Revised estimate for Rs 7 Mooof for fe
of Thyagaraja Square Mysor—

Subject : Revised estimate for Rs.77,000/- for formation of Thyagaraja Square, Mysore.

Report to accompany the revised estimate for formation of Thyagaraja Square, Mysore.

CROSS SECTION OF MASONRY BOX DRAIN

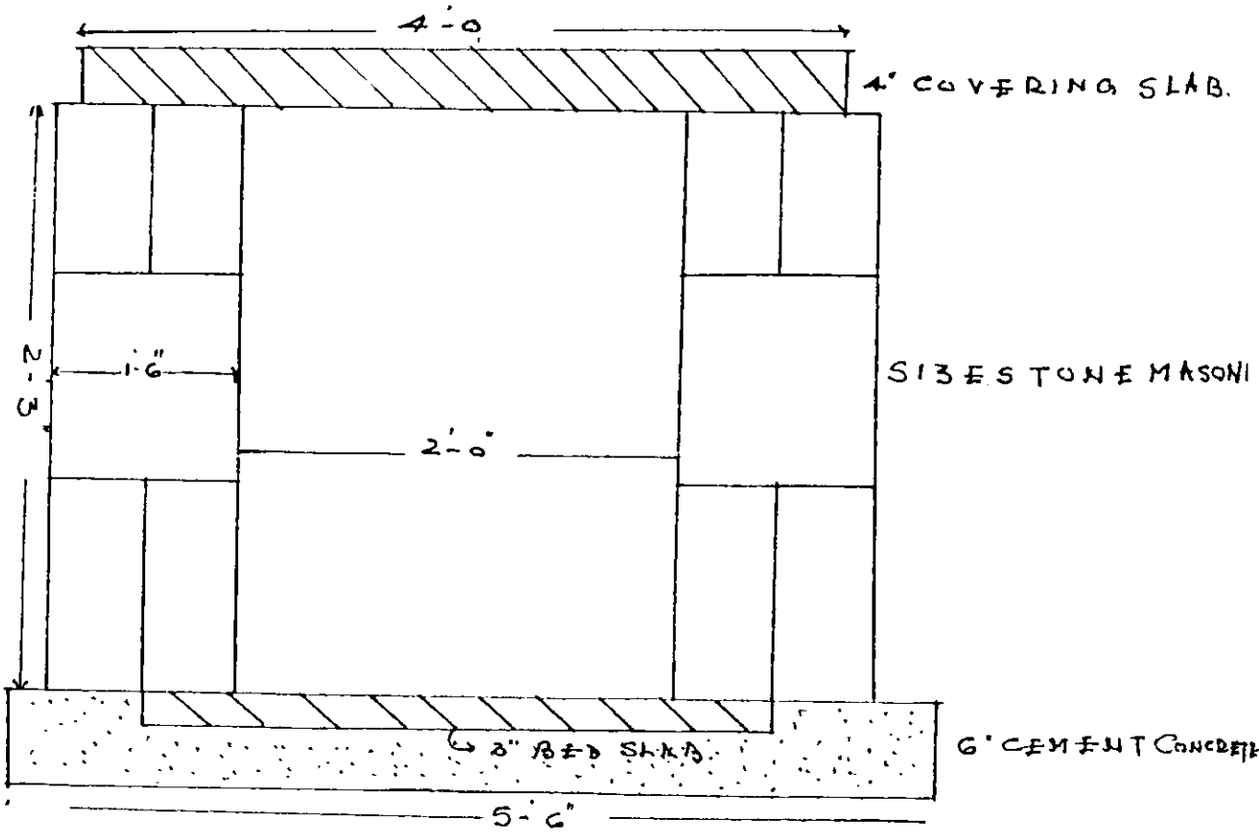
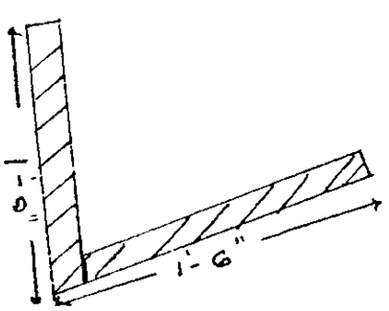
Re-transmitted: The estimate is not susceptible of scrutiny as no plans and sections have been furnished They are necessary.

The estimate is not susceptible
of scrutiny as no plans and
sections have been furnished.
They are necessary.

1. Necessary plans and sections to enable scrutiny have been furnished.
